# Amendments for 2023

## Service and Installation Rules

Empowering South Australia

Figure 27 Drawing modification

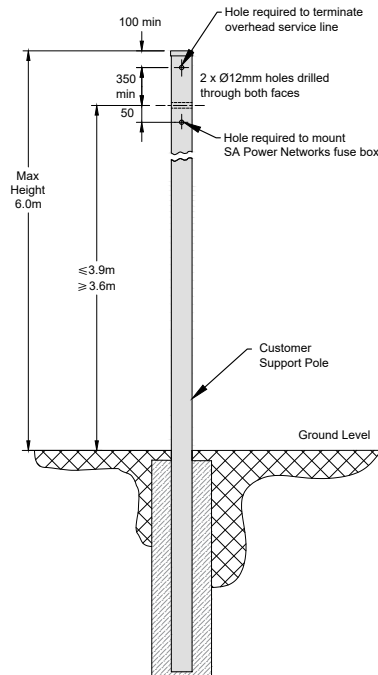
Figure 27 asks for 3 x 18mm holes. Should only be 2 x 18mm holes.

Added text to Note 2 regarding wall thickness of customer support pole

Modified Figure 27

Note 2. Customer support pole to be a minimum of 100mm galvanised SHS (Square Hollow Section) and be able to withstand a pulling force of 2kN. Refer to AS/NZS 3000 for final pole selection including the thickness of the steel wall.
